IN RE: TAMPA ELECTRIC COMPANY
BIG BEND STATION UNIT 4
POWER PLANT SITING CERTIFICATION
APPLICATION PA 79-12
REQUEST FOR MODIFICATION

FINAL ORDER

TAMPA ELECTRIC COMPANY
POWER PLANT SITING APPLICATION
BIG BEND STATION UNIT NO. 4,
PA 79-12

3. Pursuant to Florida Administrative Code Rule 17-17.211(4), Tampa Electric Company seeks a modification of Conditions II.A.10., II.B.1., II.B.2.b., III.D., III.E., XXVIII. and XXX., which provide as follows:

Plot plan, Big Bend Station.

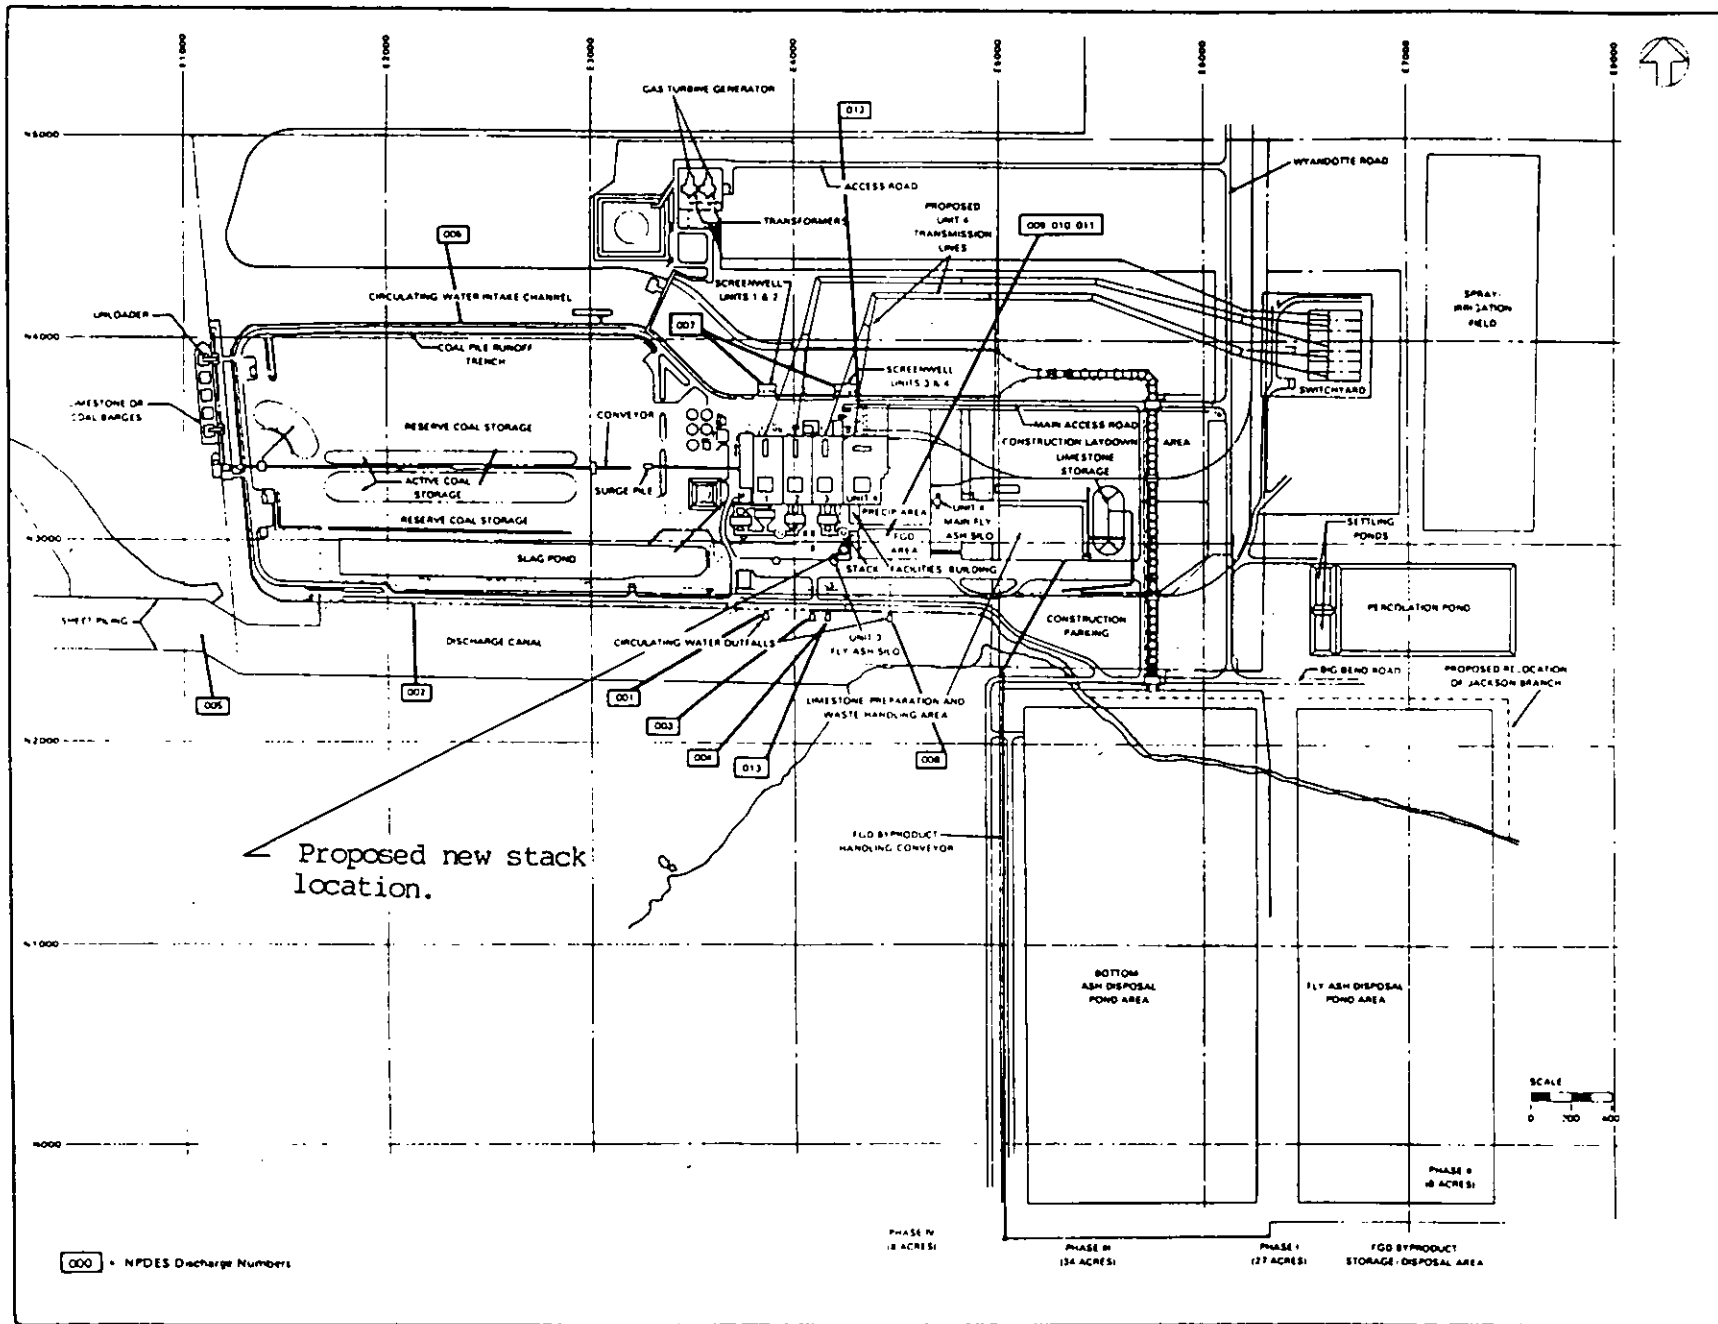
The new stack for Unit 4 will be constructed on the west side of the flue gas desulfurization system and directly south of the existing eastern most stack. The location is illustrated on the attached plot plan. The engineering and construction effort associated with locating the new stack in this area will not delay the Unit 4 commercial operation date.

The new stack height will be 490 feet with a maximum inside diameter of 24 feet. These dimensions are equivalent to those of the two existing stacks. These physical dimensions of the new stack coupled with the fact that there will be no change in Unit 4 air emissions or flue gas flow parameters as a result of the addition, make the Unit 4 air quality impacts of the new stack scenario equivalent to the air quality impacts originally predicted for a shared common stack with Unit 3 off-line, a case detailed in the Unit 4 PSD application.
